Re: Docket No. 50-275-OL  
 Docket No. 50-323-OL  
 Diablo Canyon Units 1 & 2

Enclosed in support of our operating license application are responses to informal questions 1 through 10 transmitted to PG&E in an August 4, 1978 memorandum on the subject of seismic qualifications.

This package contains non-proprietary responses to informal questions 1 through 10 transmitted to PGandE in an August 4, 1978 memorandum on the subject of Seismic Qualifications.

FIGURE 4 (cont'd)

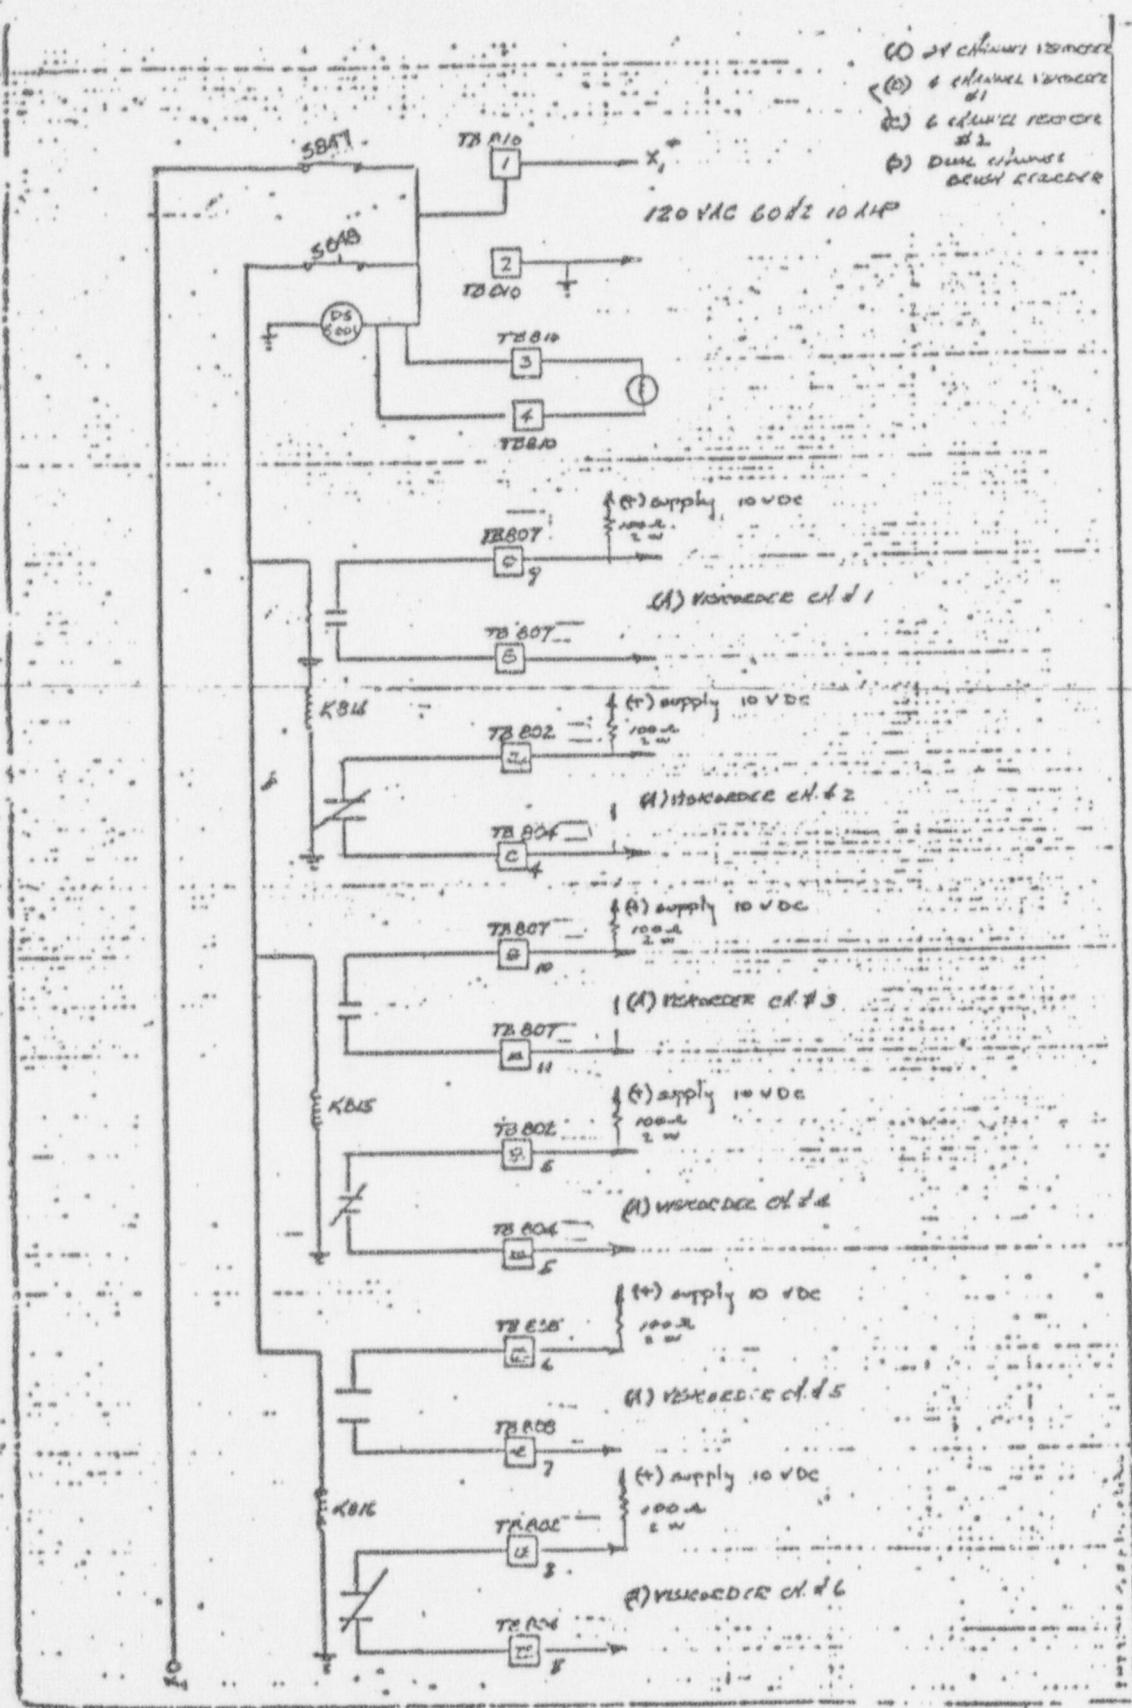
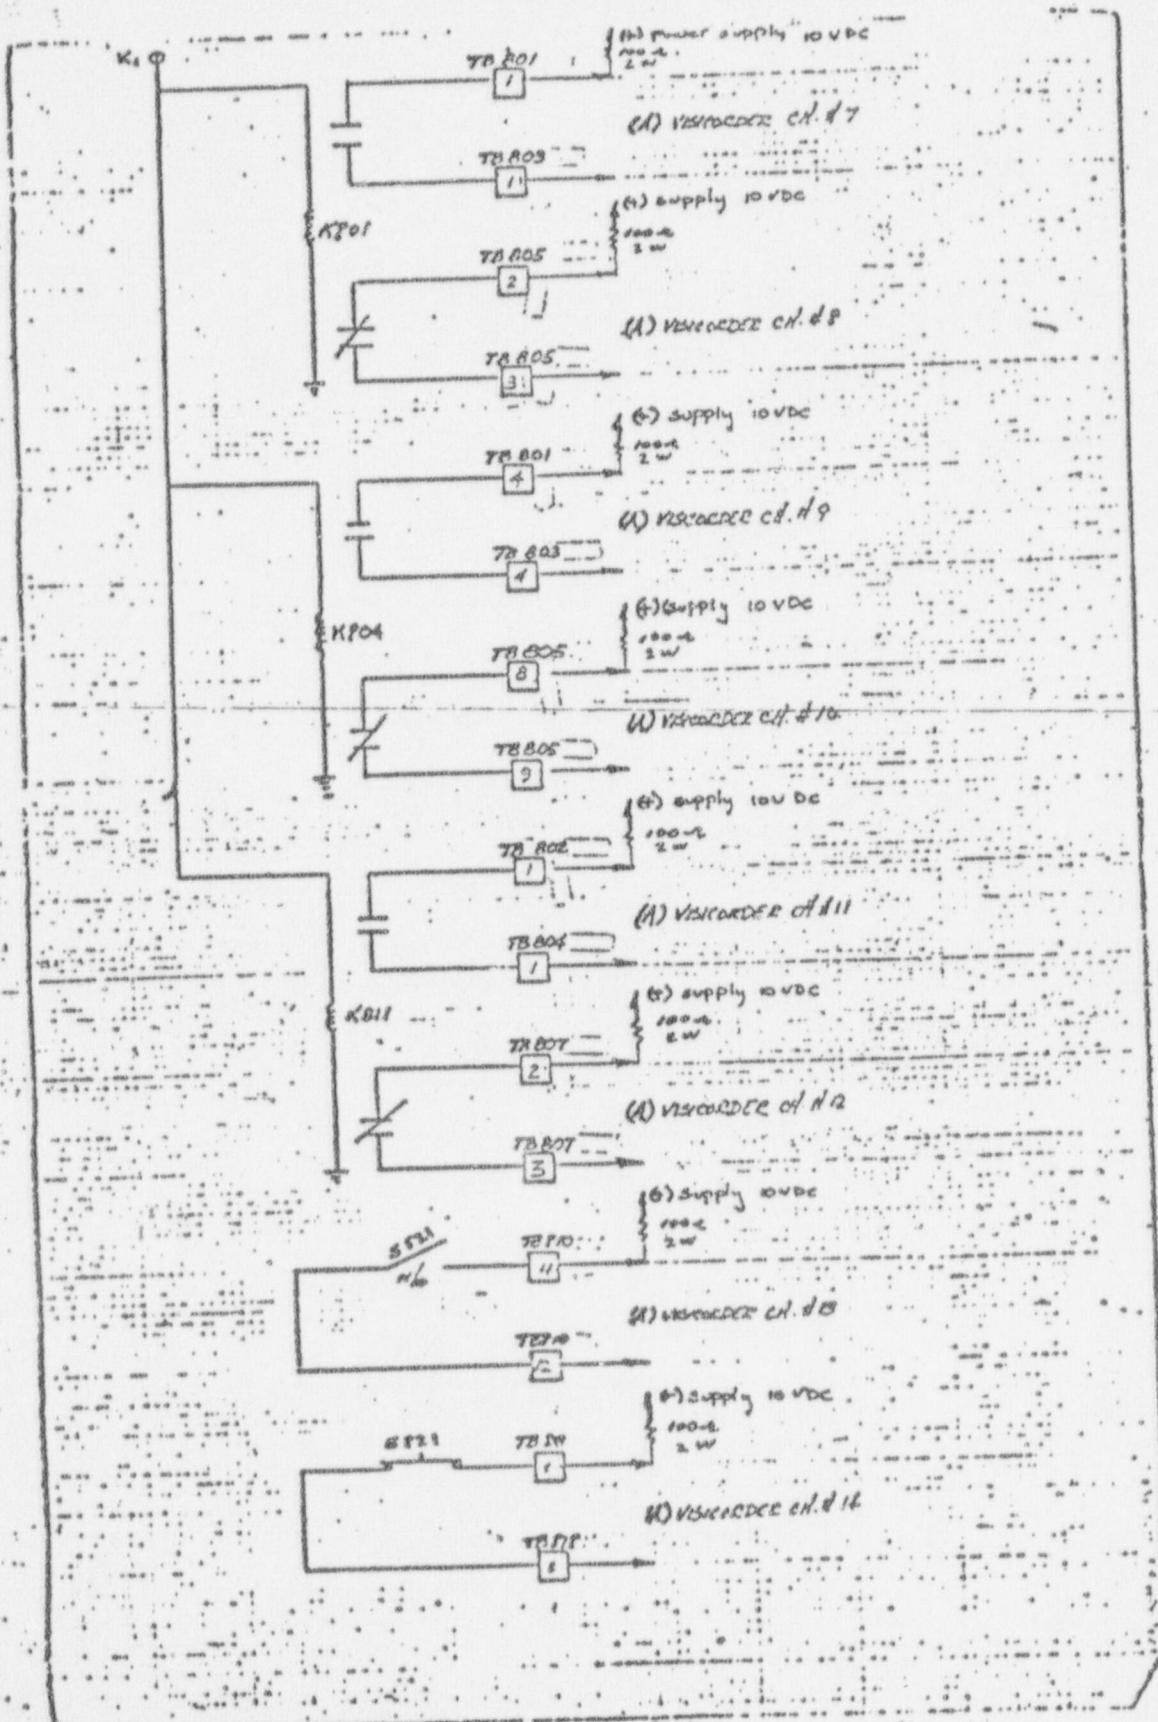
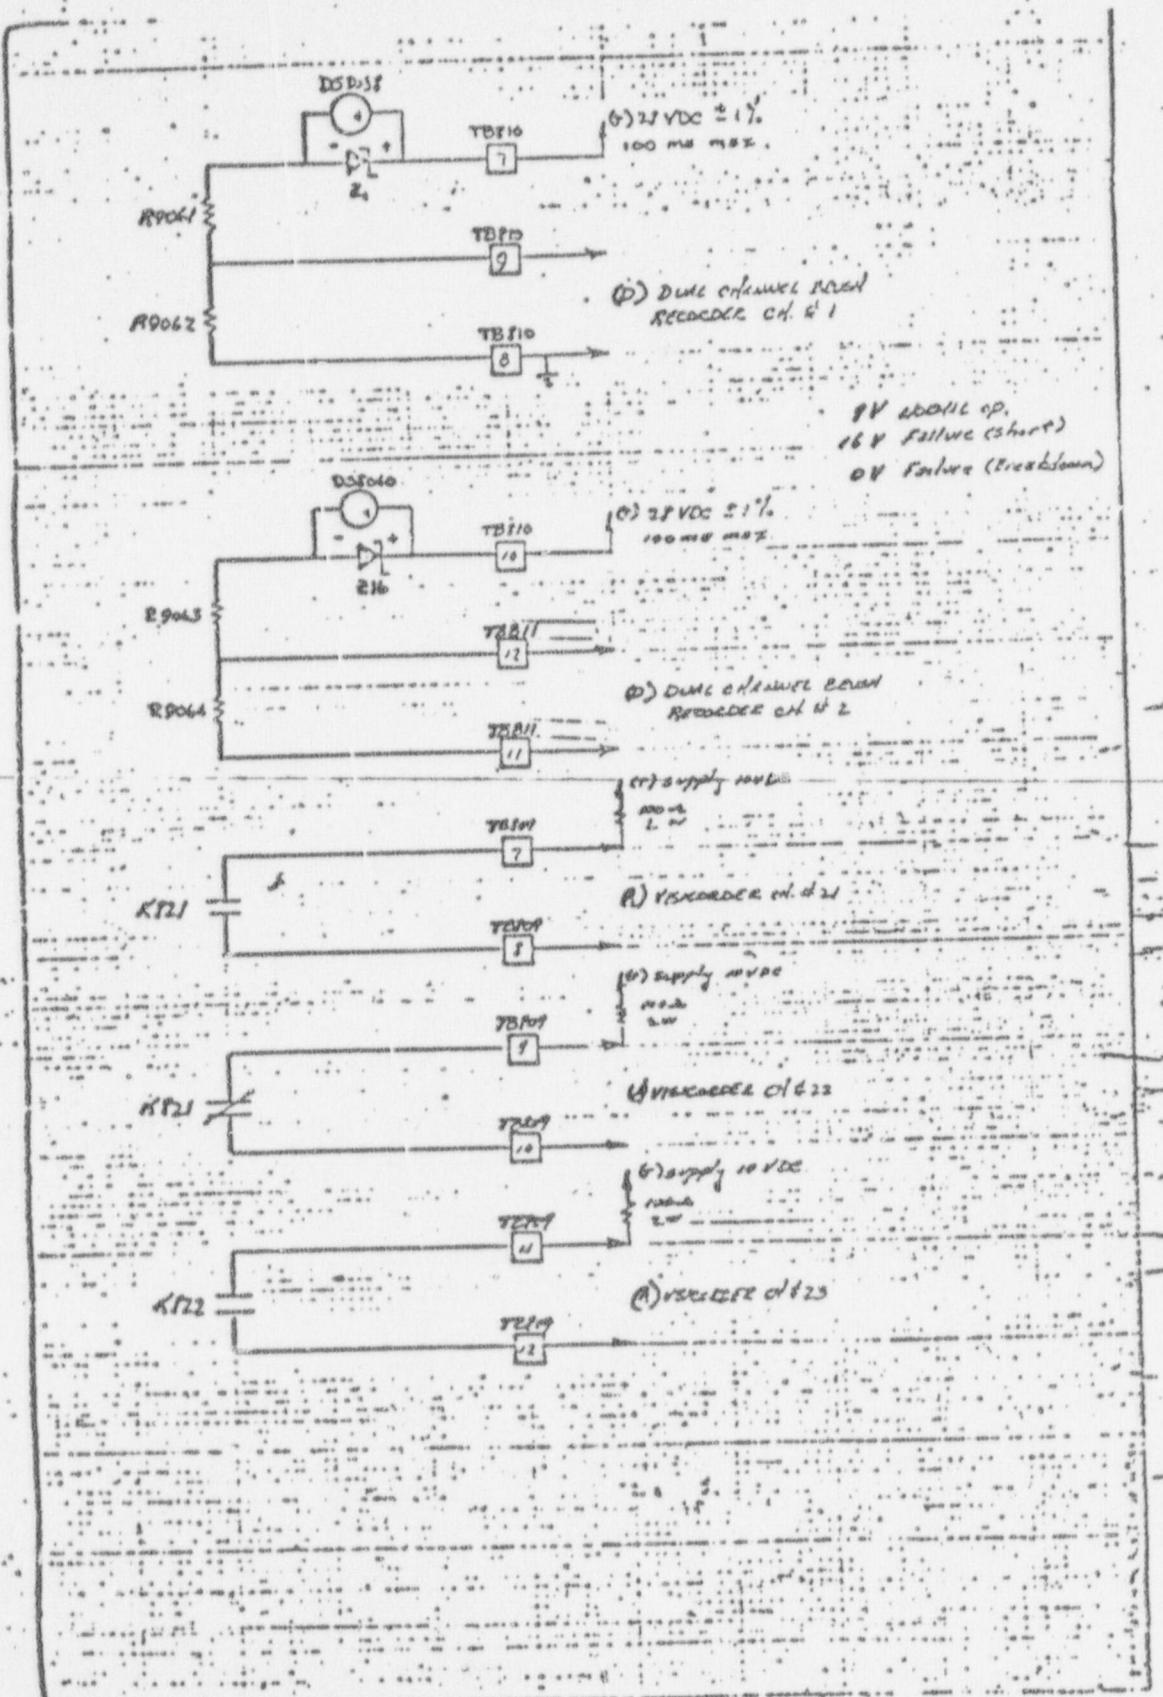
Provide electrical schematic diagrams of the test cabinet circuitry, describe the test set up, and identify the selected relays, switches, and components monitored during testing. Justify the seismic adequacy of relays, switches, and components that were not monitored during seismic testing.

Figure 4 shows the electrical test setup for monitoring selected switches, relays, and resistor-light-diode combinations of the Safeguards Test Cabinet during its seismic test. You will note that normally open and normally closed contacts of switches S804, S807, S818 and S821 were monitored, as were normally open and normally closed contacts of relays K801, K804, K811, K821 and K822. Two light-diode combinations, DS8038 and DS8040 were also monitored for continuity. Component location is shown in Figure 5.

Switches located in the top row (middle and side) and 3rd row (middle) were monitored. Relays located in the top row (side and middle), 2nd row (middle) and bottom row (side) were monitored.
